MISSISSIPPI POWER & LIGHT COMPANY

SUBJECT: Grand Gulf Nuclear Station  
Units 1 and 2  
Docket Nos. 50-416 and 50-417  
File 0260/0862/L-340.0/L-334.0  
Transmittal of Proposed FSAR  
Changes and Responses to  
NRC Formal and Informal  
Questions  
AECM-81/345

- Attachments:
1. Question and Response 260.1
  2. Revised Question and Response 362.7
  3. HGEB SER Open Item - Ultimate Heat Sink
  4. NRC Concern - Shared Systems
  5. SER Open Item - Soil-Structure Interaction

MISSISSIPPI POWER & LIGHT COMPANY GRAND GULF NUCLEAR STATION UNITS 1 & 2 FINAL SAFETY ANALYSIS REPORT	SETTLEMENT VS TIME RADWASTE BLDG/CONTROL BLDG FIGURE 2.5-75d SHEET 2 OF 2
--	---

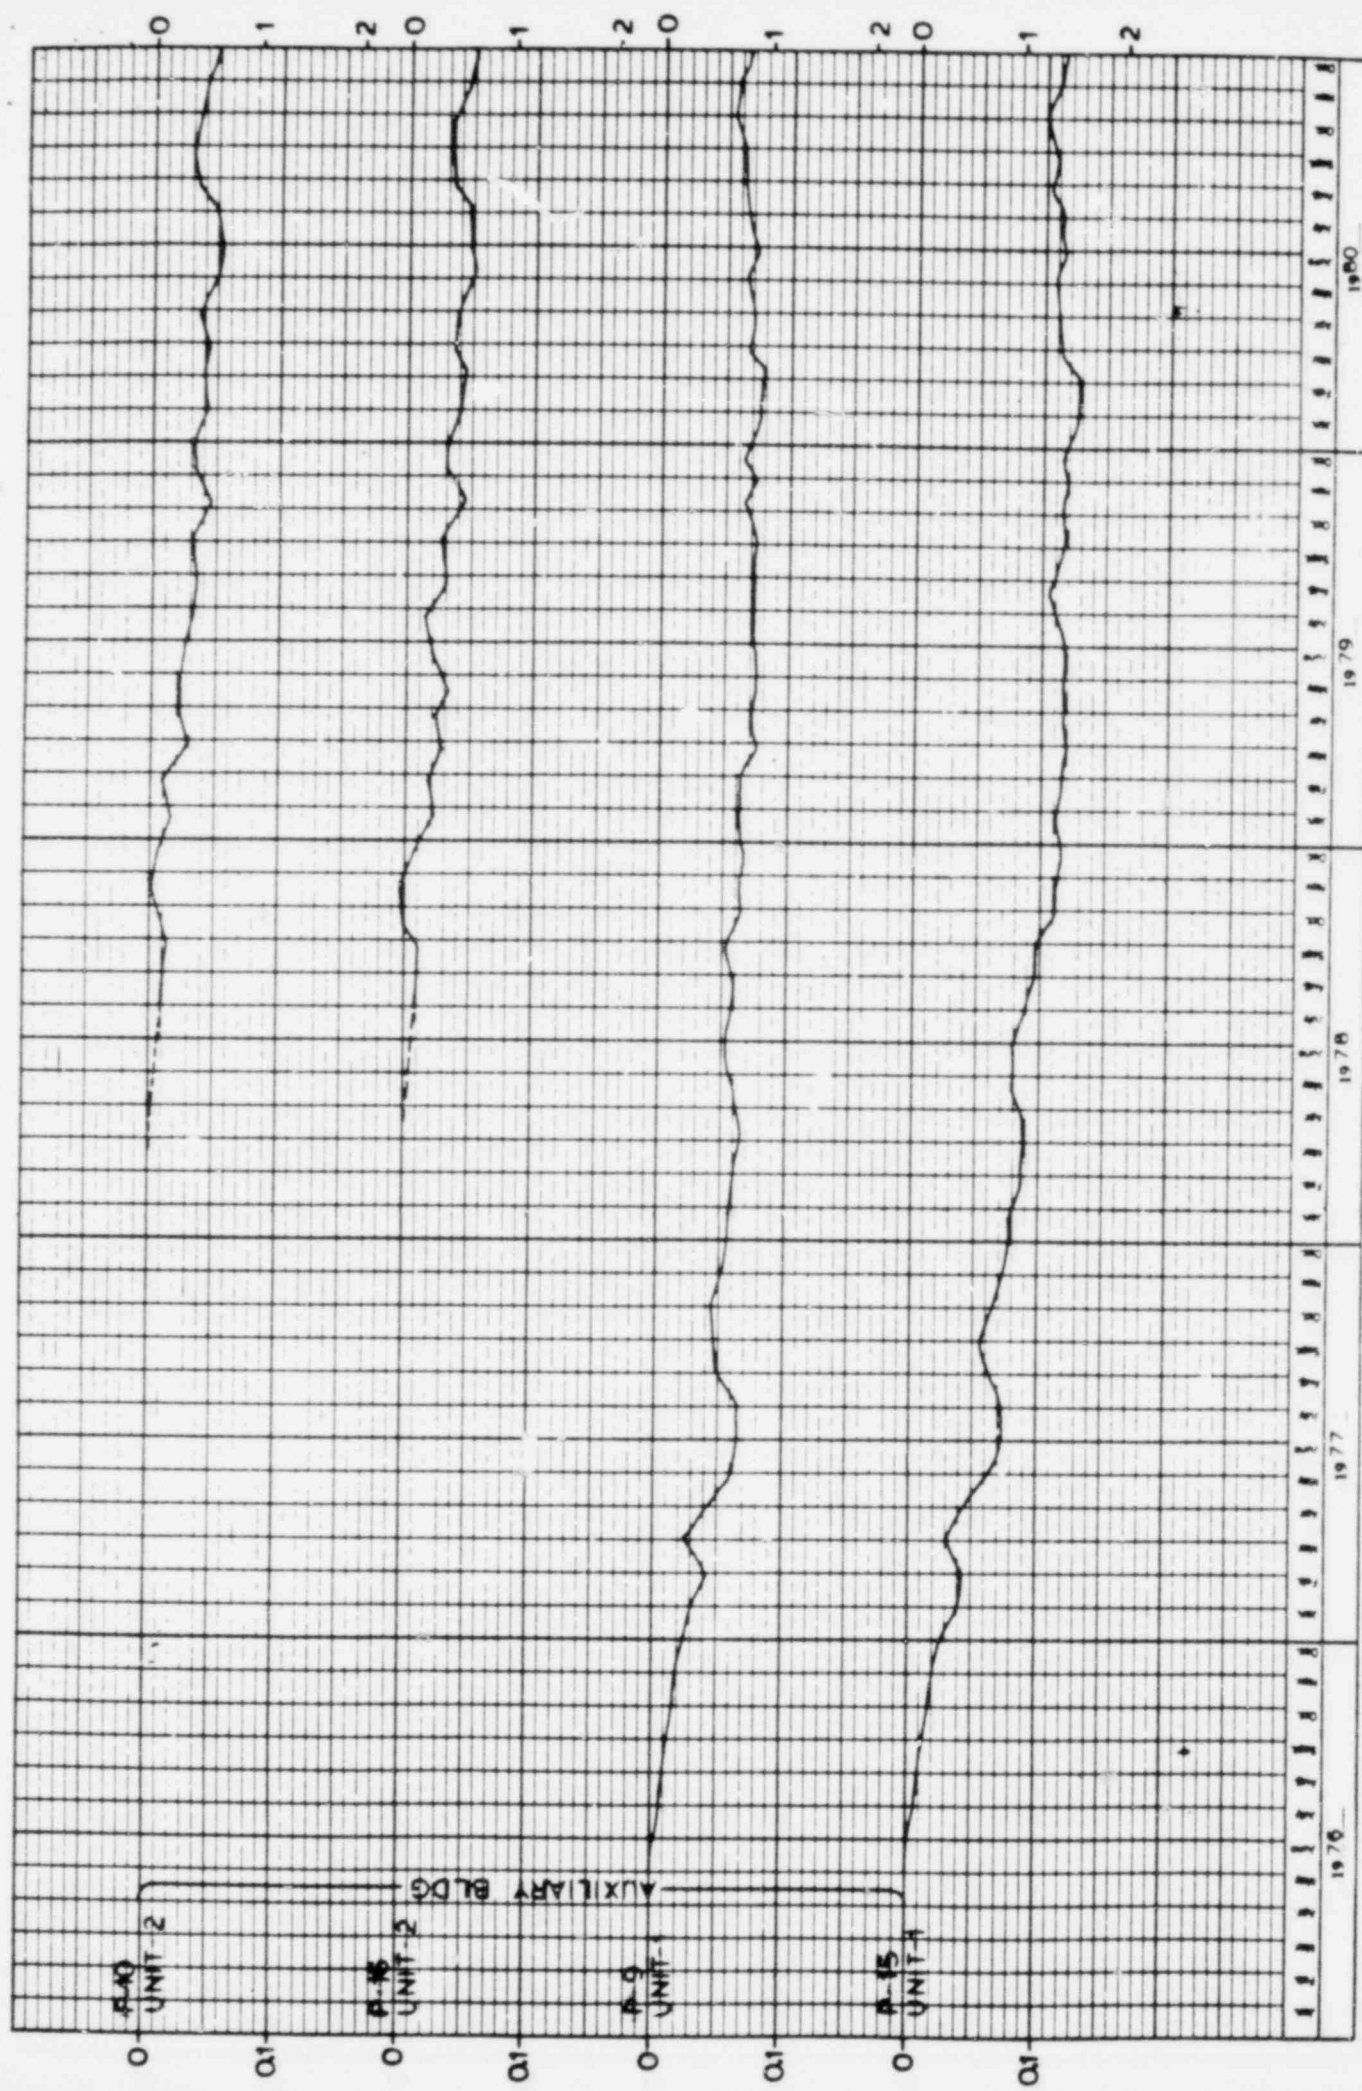
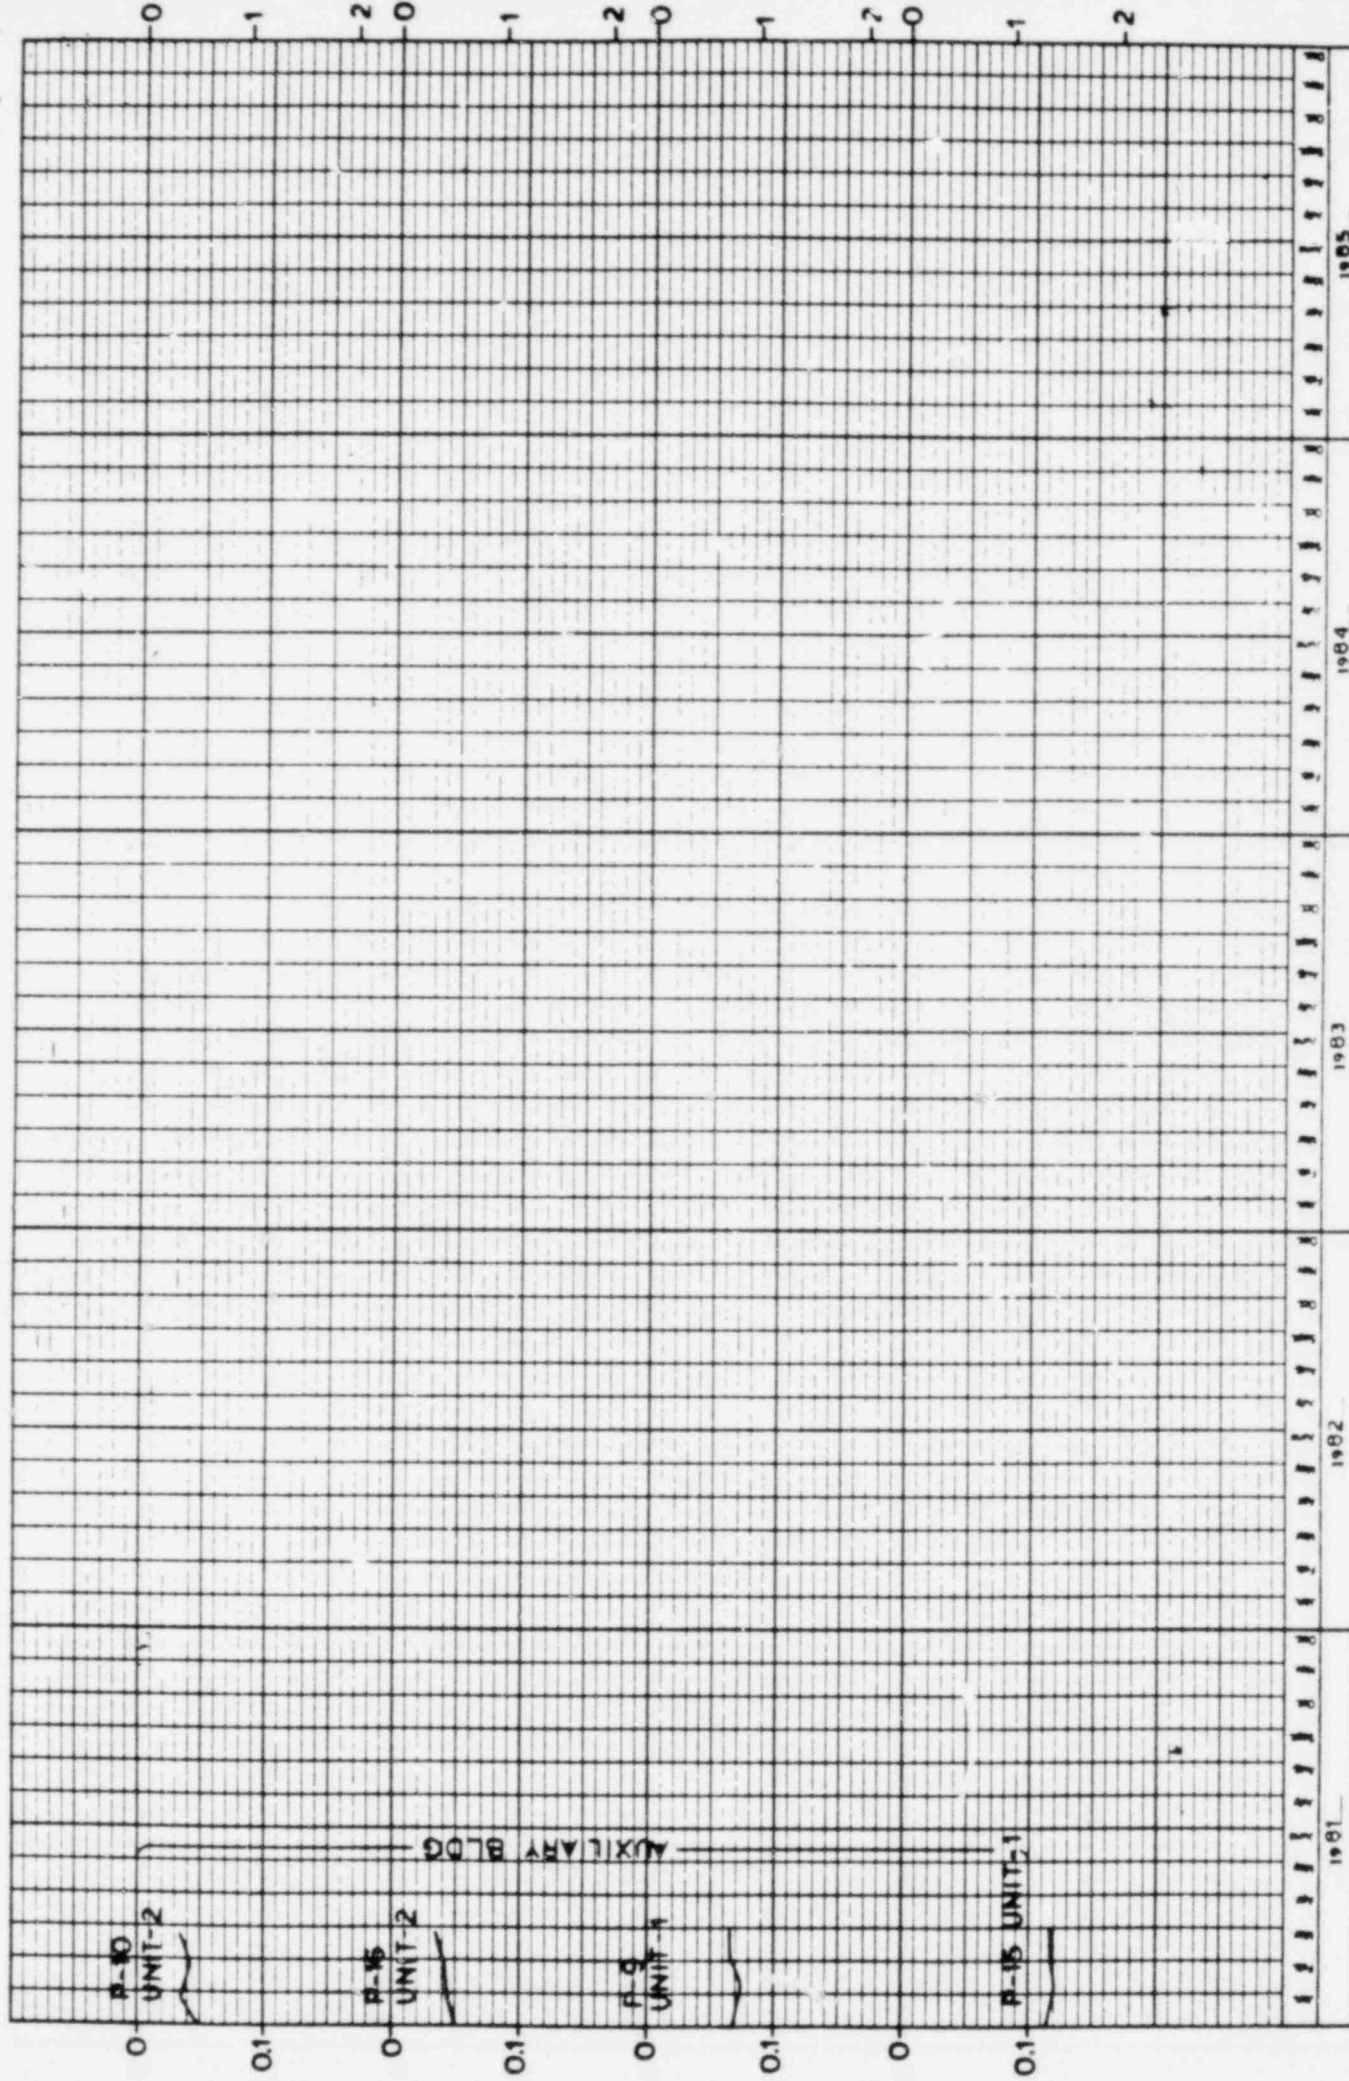
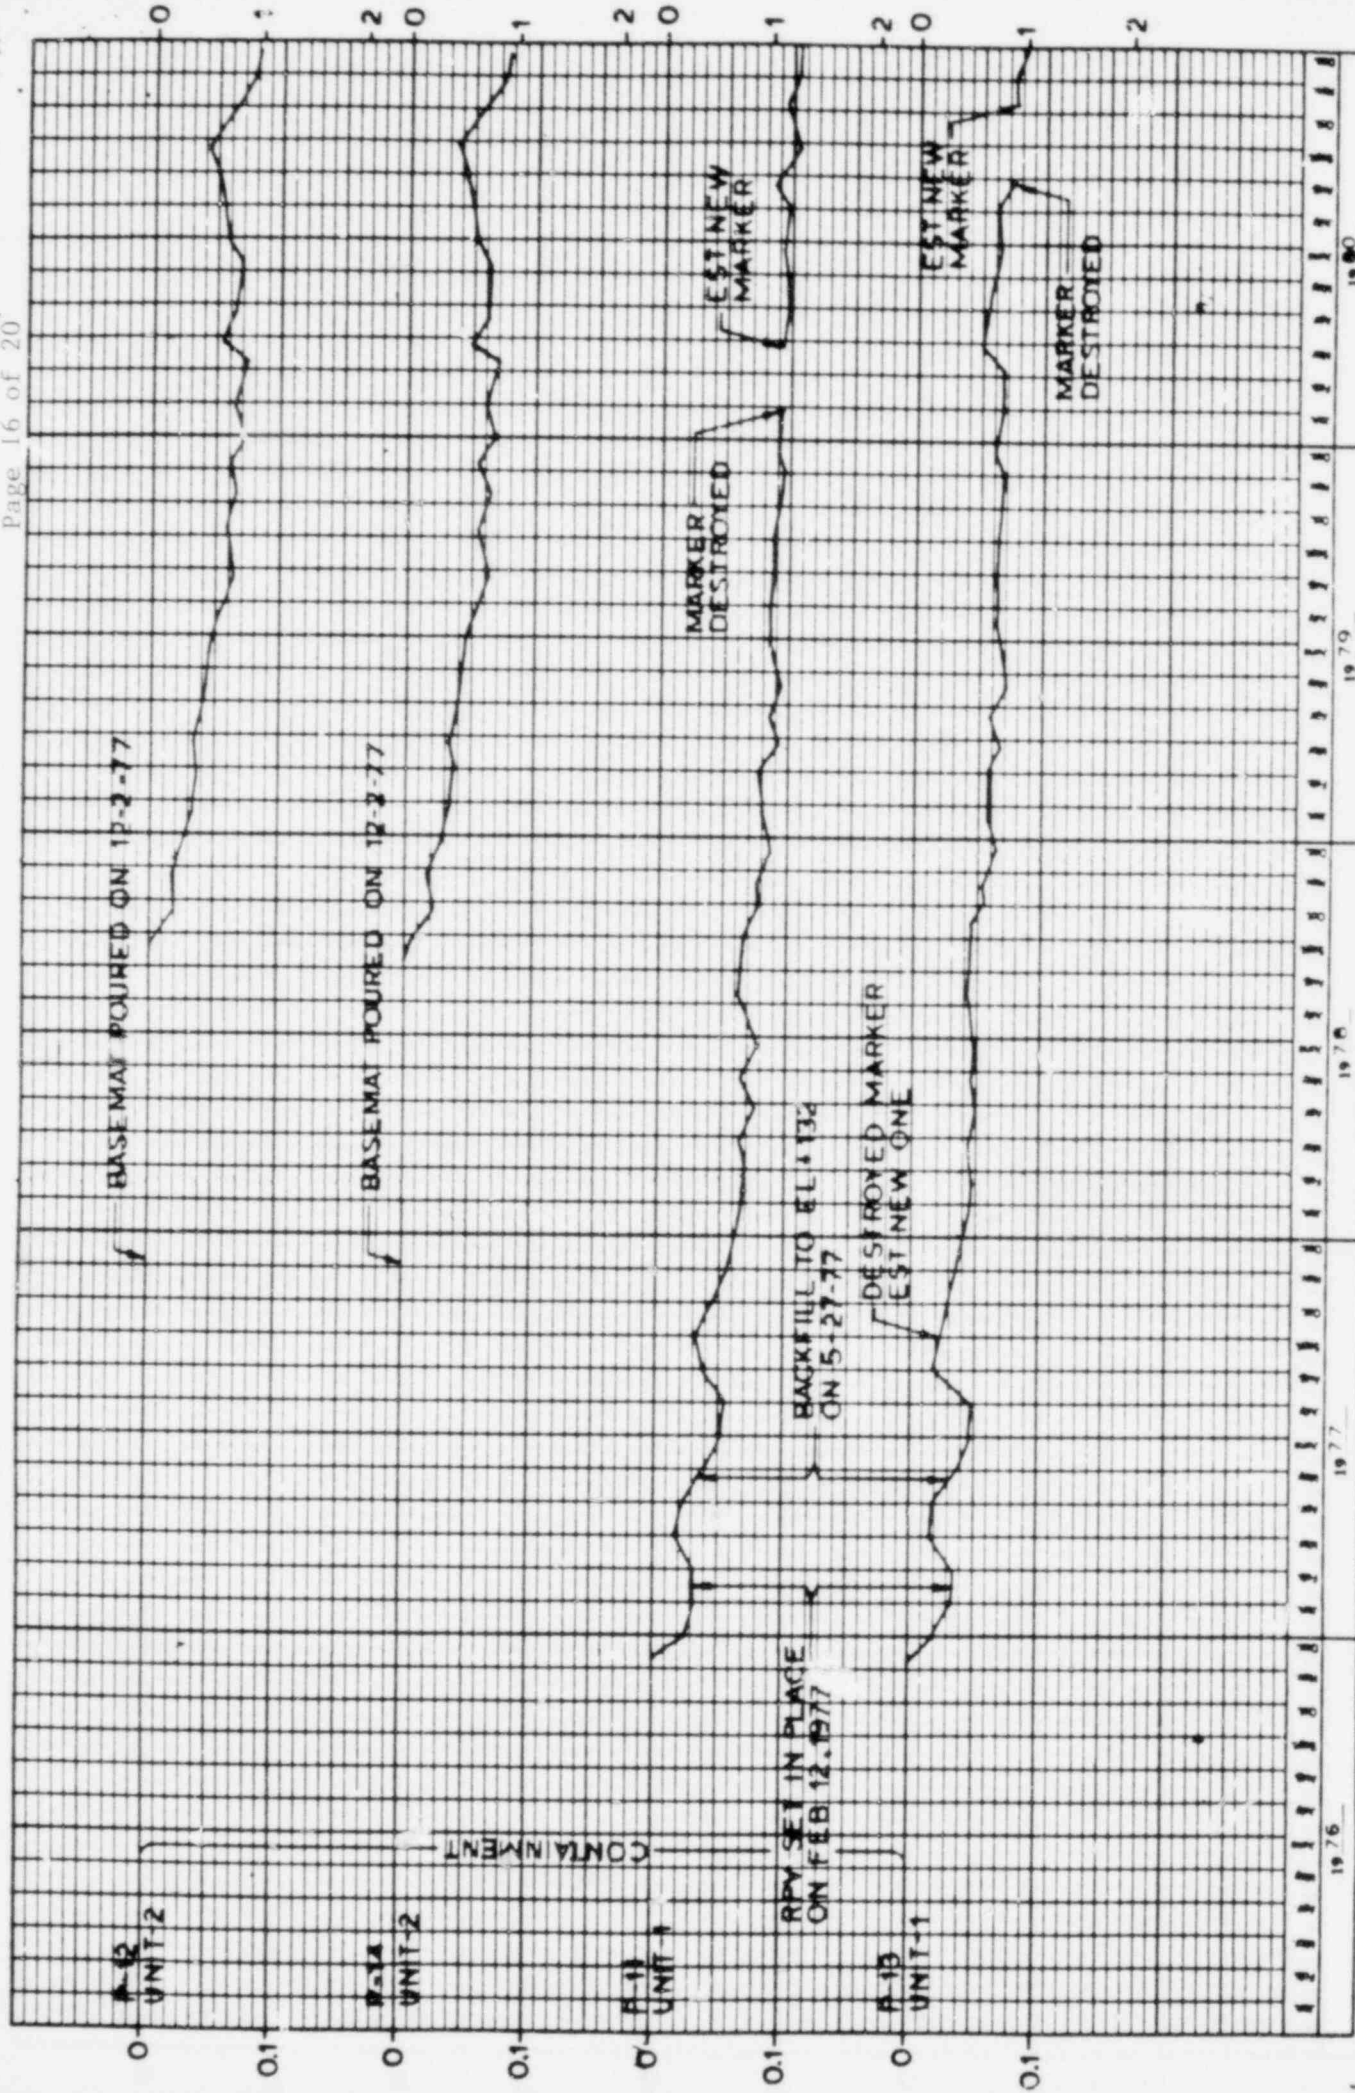
362.7 Your response to NRC Question 362.5 (page Q&R 2.5-14, Amendment 30) is not complete. Indicate what measured value of differential settlement would cause code allowable stresses to be exceeded for individual buildings and buried piping and require notification of NRC. Provide a table of these values and the limiting stress criteria. Update the plots which show settlement recorded to date versus time; this is particularly important since construction of Unit 2 was still underway when your response to Question 362.5 was being developed.

The response to this question is given in revised subsection 2.5.4.13.1, revised Table 2.5-10, and revised Figures 2.5-75a through 2.5-75h.

The settlement markers will be read at one-month intervals until construction is complete and all pools are filled with water, at which time the results of the settlement monitoring program will be evaluated and long-term monitoring of the structures will be assessed. Total settlement will not be a Geotechnical concern until the following measured values are observed:

Turbine building	3"
Radwaste building	3"
Control building	3"
Containment building	3.5"
Auxiliary building	3.5"
Diesel generator building	3"
